CERTIFICATE OF APPROPRIATENESS

Property: 1123 Jerome Street, Lot 11, Block 102, North Norhill. The property includes a one-story single-family residence situated on a 5,000 square foot (50' x 100') interior lot.

Proposal: Alteration – Addition

The applicant is proposing to add a 418 SF one-story rear addition to the existing 1,214 SF one-story home.

ATTACHMENT A

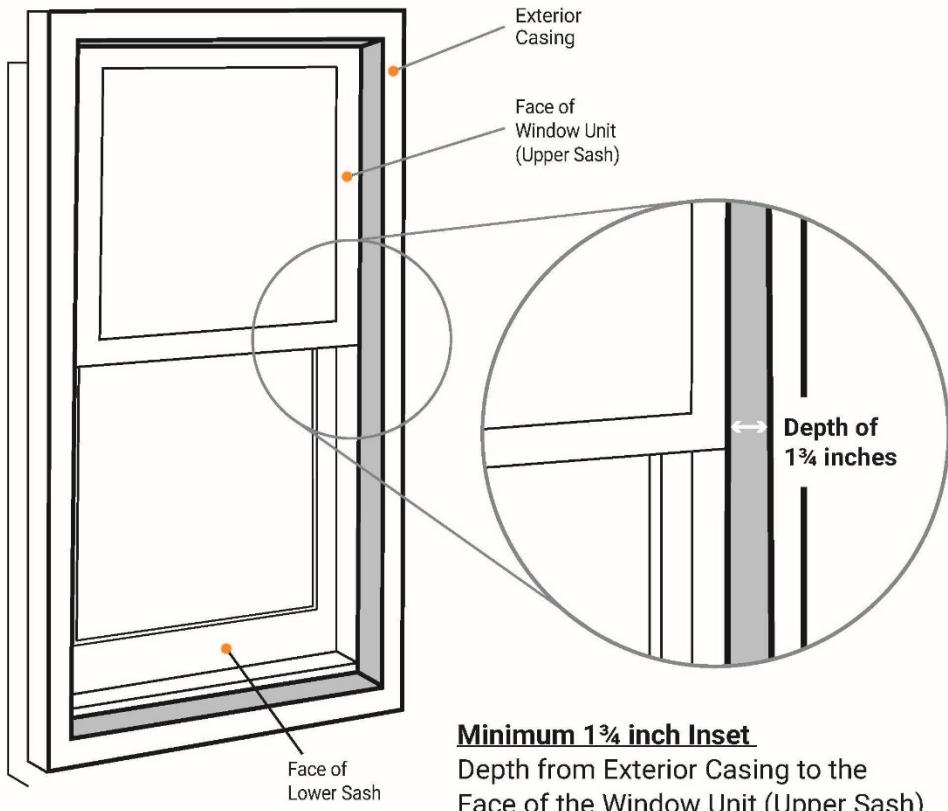
- Roof: composition shingles with a 6/12 pitch
- Existing siding: 2 ½" wood siding; proposed 5 ½" fiber cement smooth lap siding
- Current ridge height: 17'-4"; to be maintained
- Current eave height: 9'-9"; proposed 14'-2"
- Windows:
 - All new windows need to be wood, inset and recessed. See Attachment A. **Minimum 1 ¼ inch inset** depth from exterior casing to the face of the window unit (Upper Sash) Windows must be 1-over-1 if single or double-hung and equally horizontally divided. 1 ¾ inch minimum inset for Fixed Window.

Minimum 1 3/4 inch Inset

Windows must be 1-over-1
(equally horizontally divided)

1 3/4 inch minimum inset for Fixed Window
